Sunset Wilcox / 6460 Sunset
PVP Comments
October 5, 2021

360 Design

AERIAL VIEW | PLANNED SURROUNDING PROJECTS

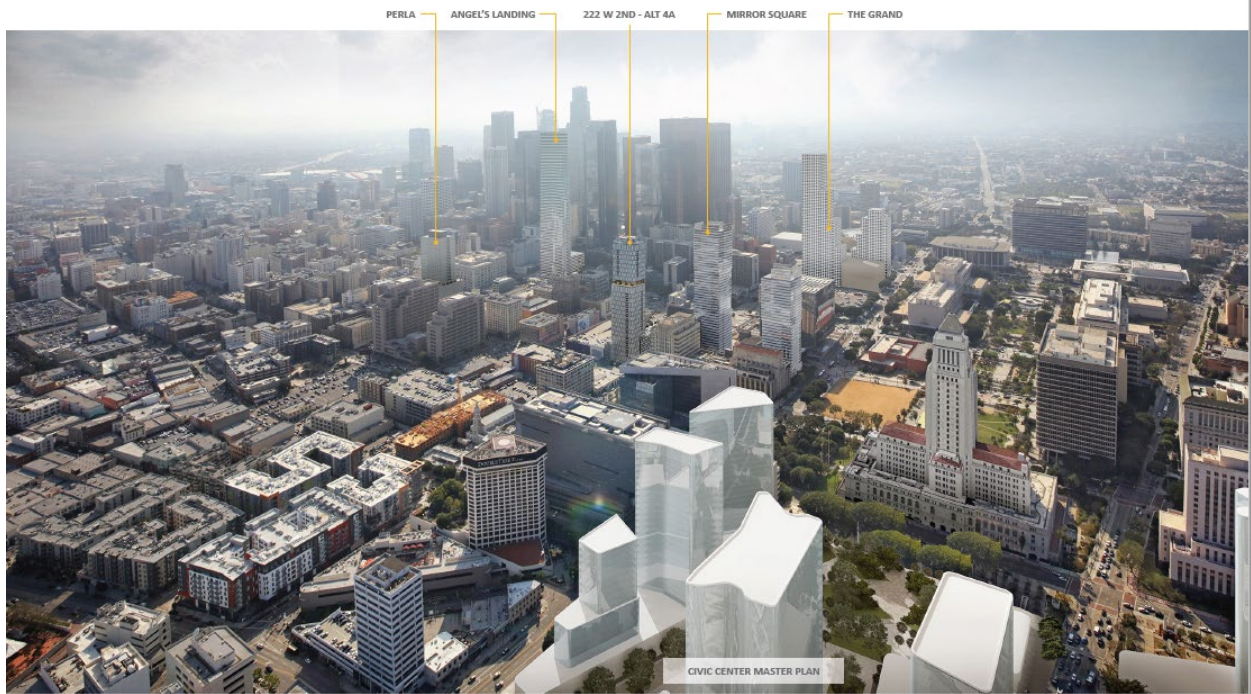
- To better understand how the area is changing, provide an aerial image that includes the project and surrounding proposed projects (Two examples provided below).
